SUBJECT: NEW VEHICLE DELIVERY HOLD
Safety Recall 19S03 – Supplement #5
Certain 2017 - 2019 Model Year Continental
Door Latch Replacement

- *Update to Technical Instructions to clarify cable routing and added Functional Check after repairs.*

FIGURE 1

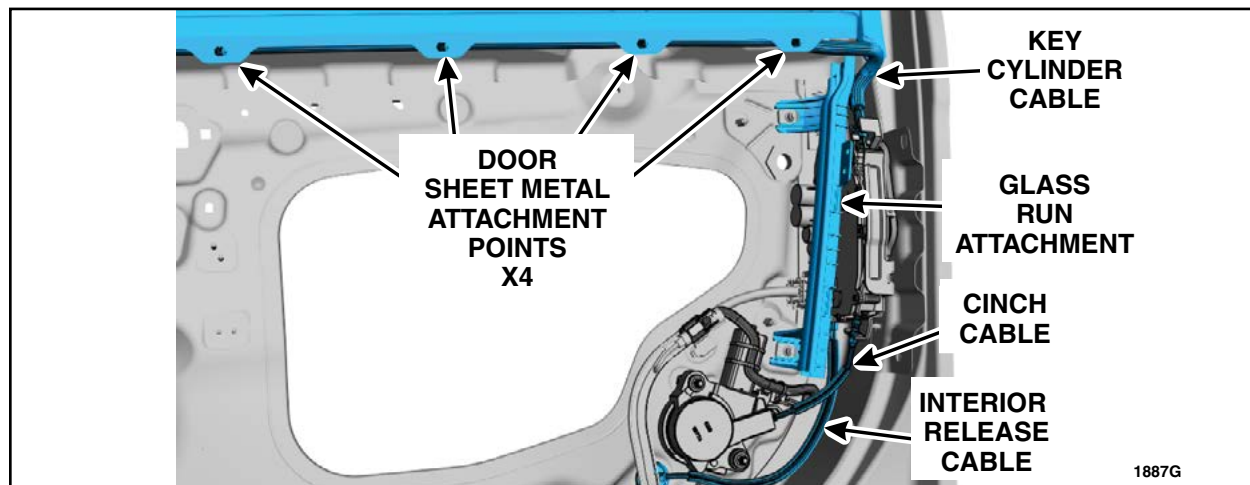
NOTICE: *Damage to the components may occur if the cable(s) are not routed correctly. See Figures 1 and 4.*

NOTE: *Ensure the cable to the backup key cylinder is routed on the outboard side of the sheet metal attachment points. See Figure 1.*

NOTE: *Ensure the interior release cable and cinch cable are routed under the glass run attachment. See Figure 1 and 4.*

NOTE: *Left Front Door shown, Right Front Door similar except for key cylinder and interior release cable. See Figure 1.*

FIGURE 2

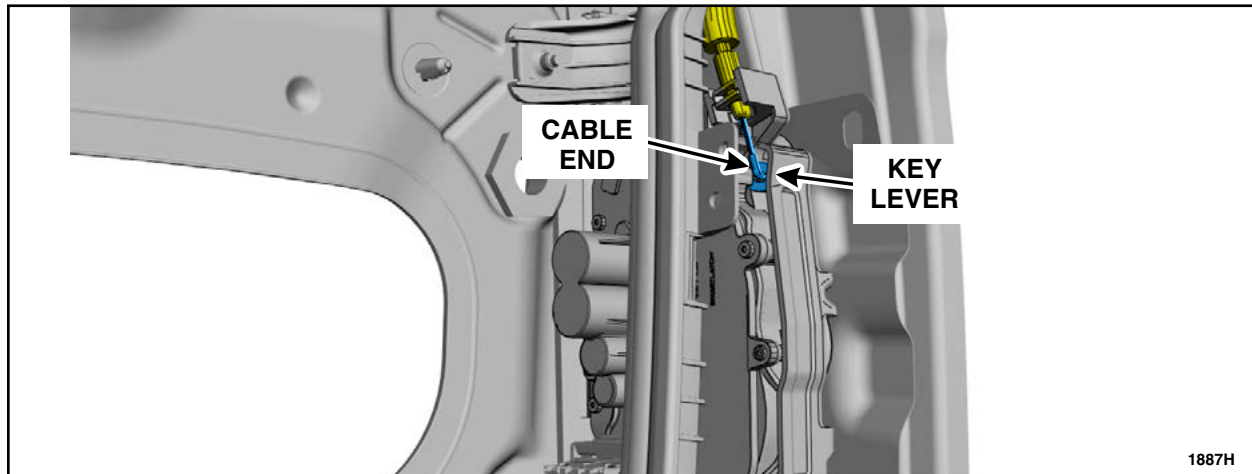
NOTE: For the left front door ensure cable end is not pushed through the key lever and that the key lever is angled in the downward direction. See Figure 2 and Figure 9.

FIGURE 3

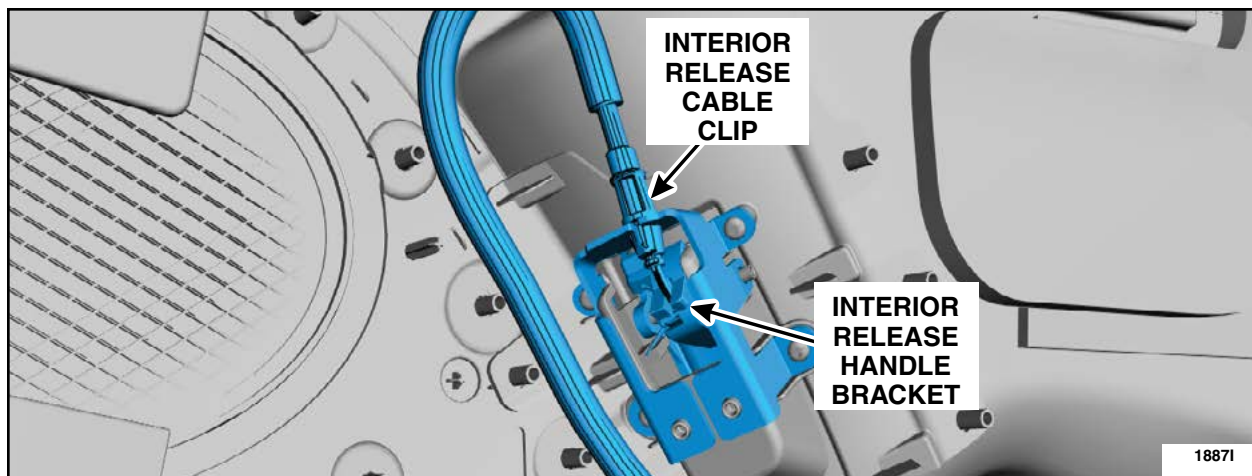
NOTE: For the left front door ensure the interior release cable clip is fully seated into the interior release handle bracket, located on the interior trim panel. See Figure 3.

FIGURE 4

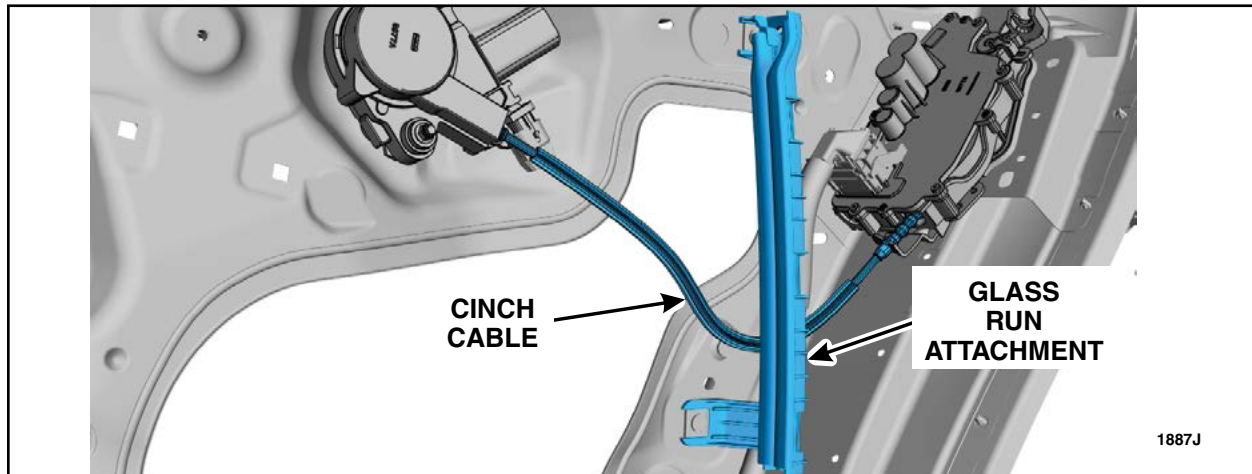
NOTE: For the rear doors (If equipped with Power Cinch Motor) ensure the cable is routed to the **inboard** side of the glass run seal. See Figure 4.

FIGURE 5

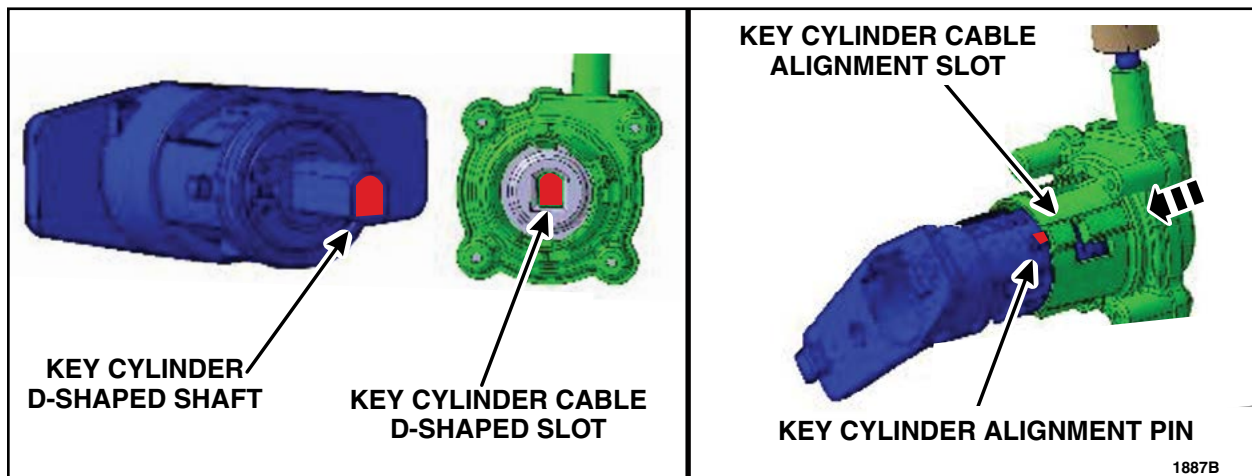
2. The D-Shaped key cylinder shaft must align with the side door key cylinder cables D-Shaped slot and align the key cylinder pin with the key cylinder cable slot. See Figure 5.

FIGURE 6

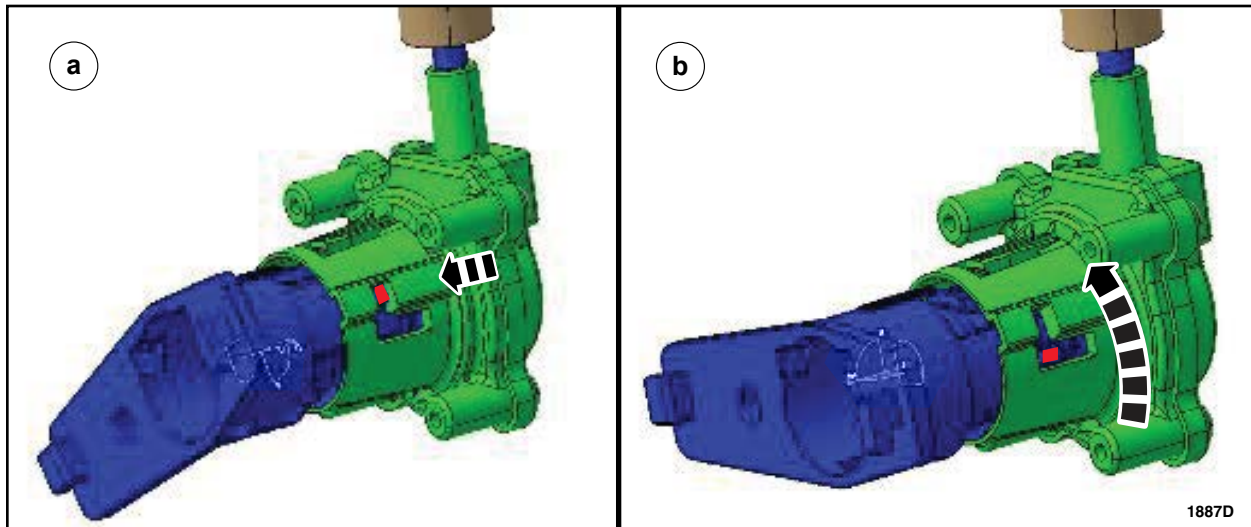
3. Install the key cylinder cable onto the key cylinder. See Figures 5,6 and 7.

- a. With the key cylinder cable slot aligned with the key cylinder pin push the cable on until it stops.
- b. Rotate the cable end until it stops.
- c. Push the cable onto the key cylinder until it stops.

FIGURE 8

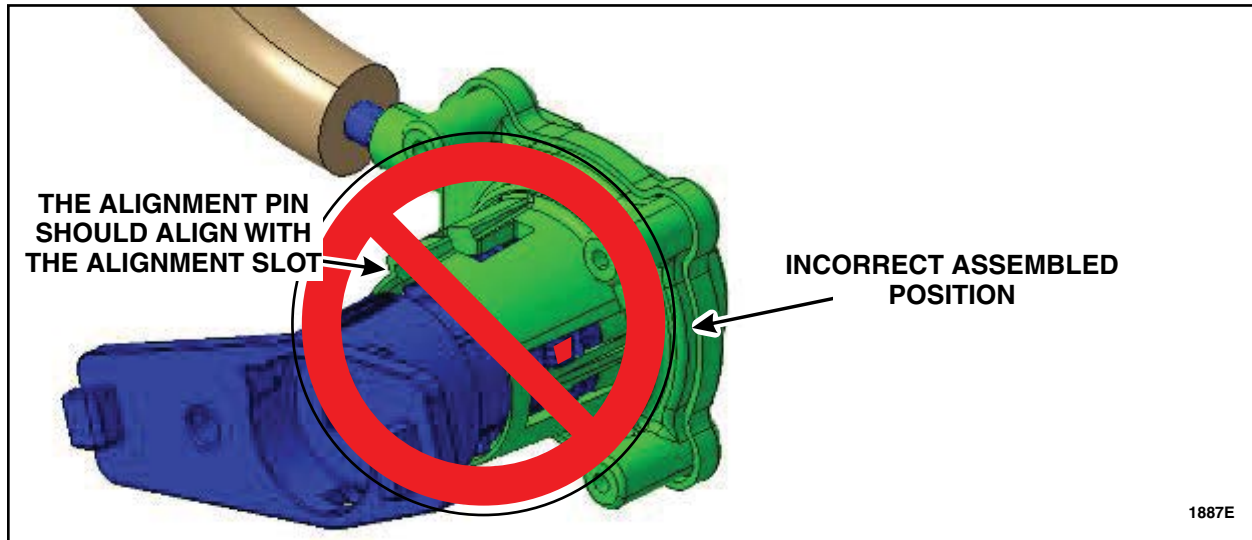
NOTE: Figure 8 shows an incorrectly assembled key cylinder and cable assembly for reference.

4. Ensure that the key cylinder cable slot is aligned with the key cylinder pin. Figure 8 shows an incorrect assembled key cylinder and cable assembly.

FIGURE 9

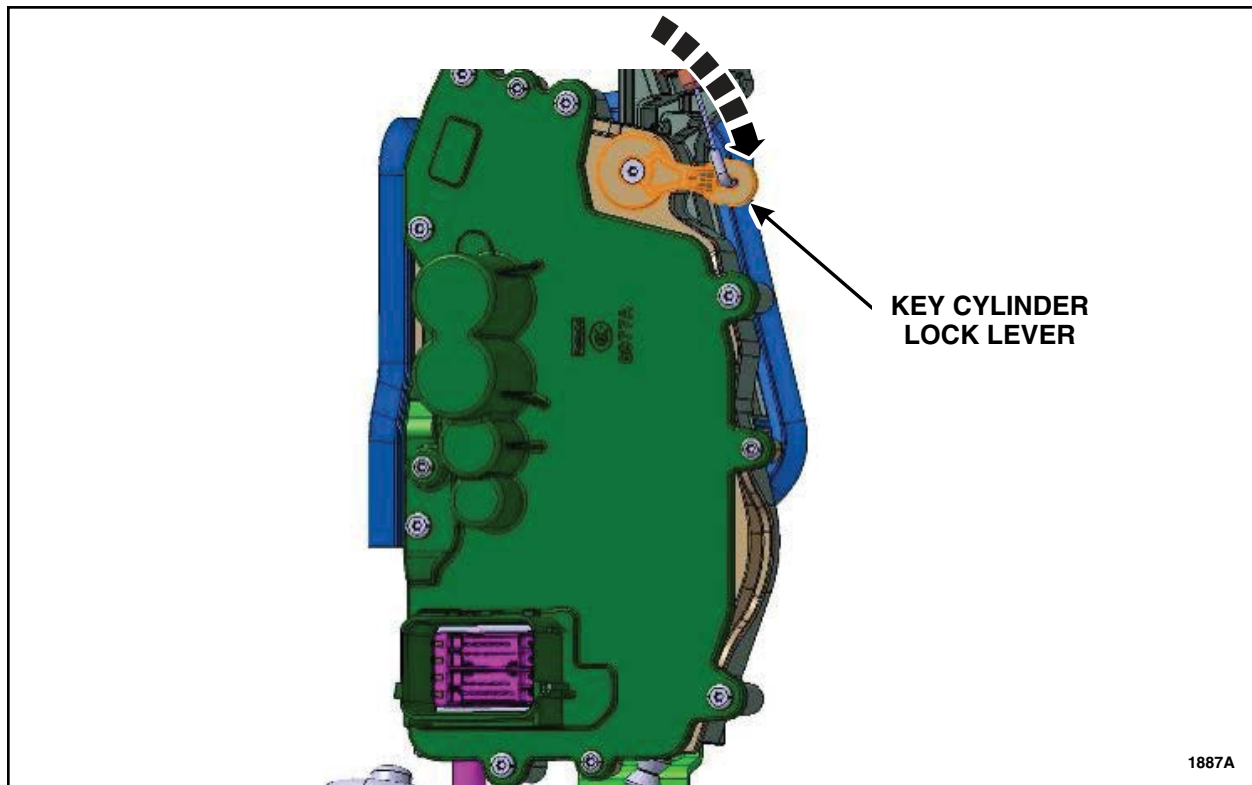
5. After the installation of the driver door E-Latch assembly, ensure that the key cylinder lock cable lever is in the downward position before installing the door trim panel. See Figure 9.
